ORIGINATION FORM

Proposed Revisions to a Standard Plans Index
(Please provide all information — Incomplete forms will be returned)

Index Number: 700-030
Sheet Number (s): 1
Index Title: Wind and Hanger Beams for Overhead Signs

FRONT ELEVATION

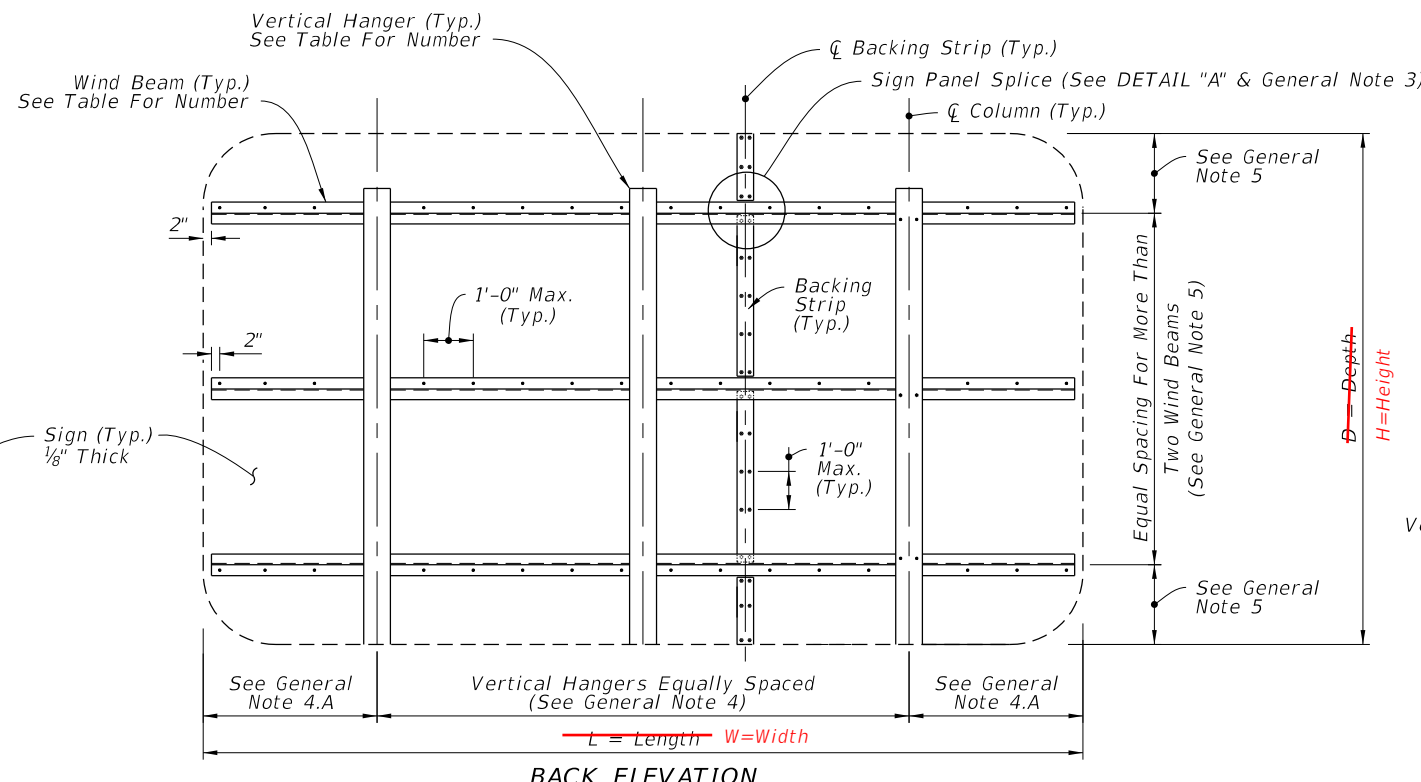
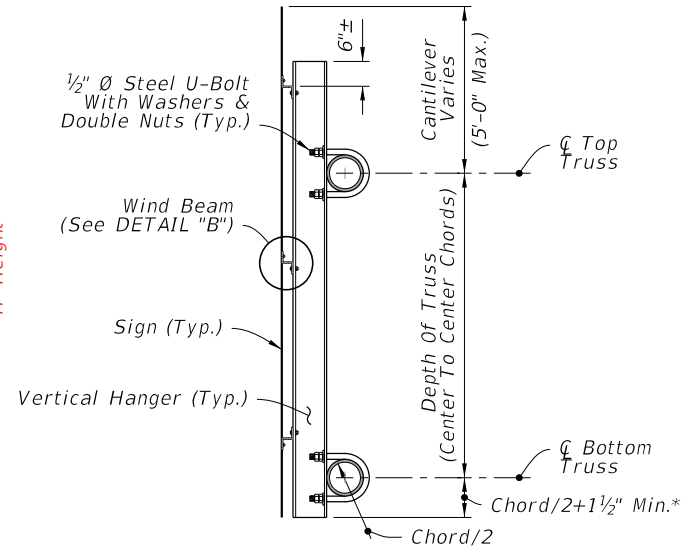
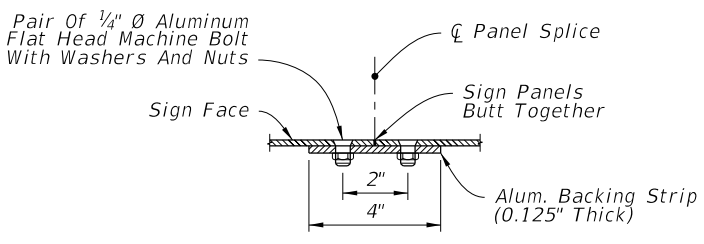
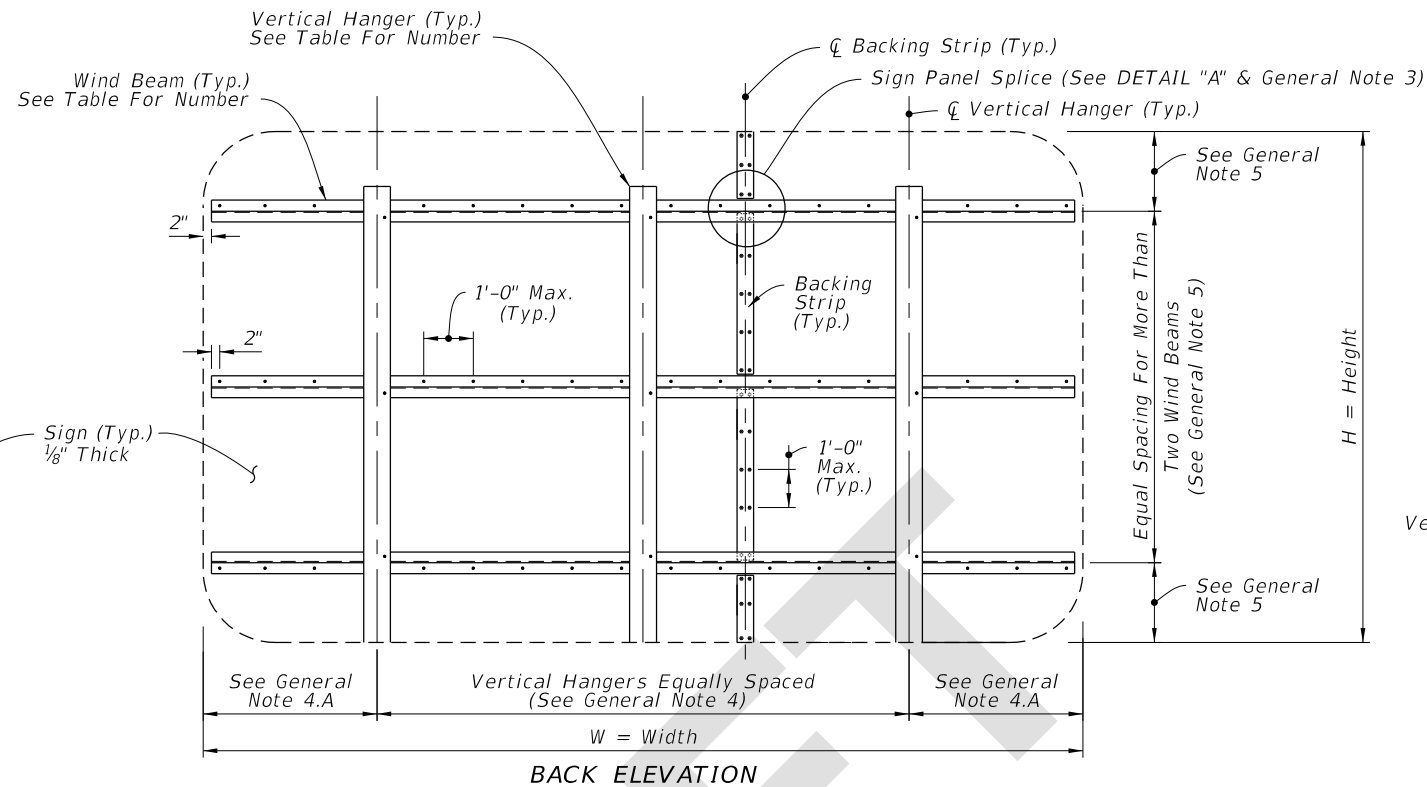
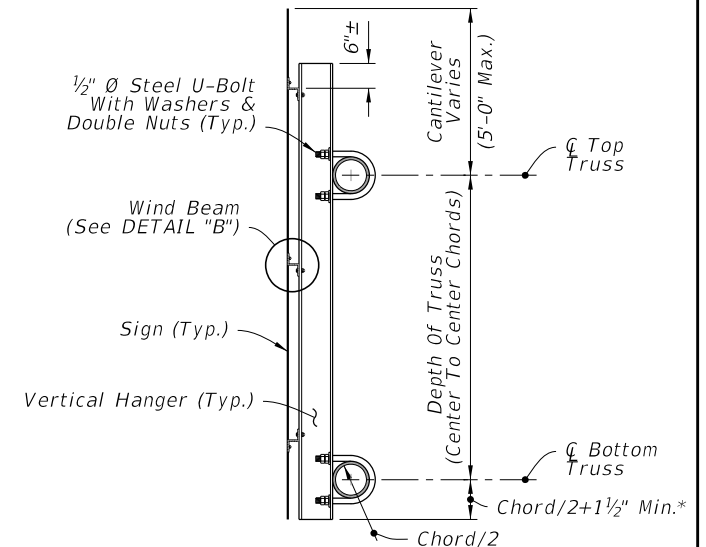
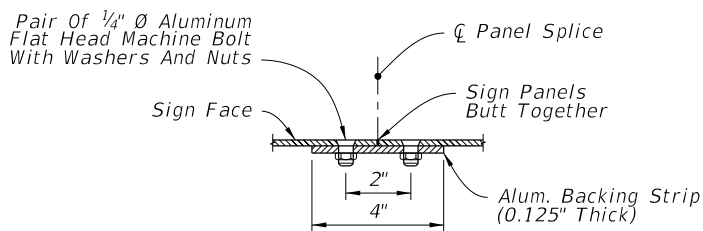
Changed all reference of length to width and all reference to depth to height.

Change to "W"

Change to "H"

PLAN VIEW

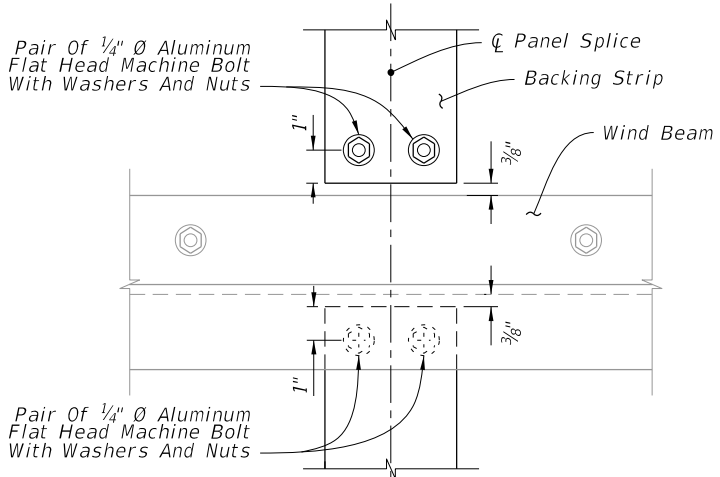
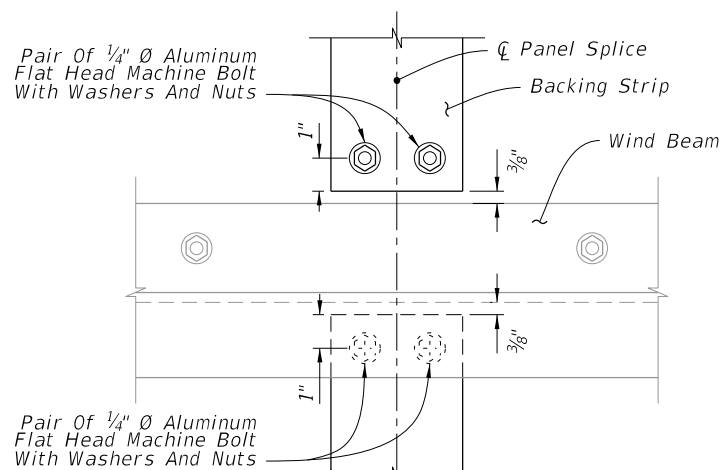
CHANGED TO: Height (H)

CHANGED TO: Width (W)

WIND BEAM TABLE (Z 3 x 2 ¹¹ / ₁₆ x 2.33)					
Number of Horizontal Wind Beams Based on Sign Height (H)					
2 Beams	3 Beams	4 Beams	5 Beams	6 Beams	
H ≤ 5'	5' < H ≤ 9'	9' < H ≤ 12'	12' < H ≤ 15'	15' < H ≤ 18'

HANGER TABLE (I 6 X 4 x 4.69 or Z 5 x 3 ¹ / ₄ x 4.01)					
Number of Vertical Hanger Beams Based on Wind Speed and Sign Width (W)					
	2 Hangers	3 Hangers	4 Hangers	5 Hangers	6 Hangers
130 mph	W ≤ 20'	20' < W ≤ 30'	30' < W ≤ 40'	40' < W ≤ 50'	--
150 mph	W ≤ 18'	18' < W ≤ 27'	27' < W ≤ 35'	35' < W ≤ 45'	45' < W ≤ 50'
170 mph	W ≤ 15'	15' < W ≤ 20'	20' < W ≤ 28'	28' < W ≤ 35'	35' < W ≤ 43'
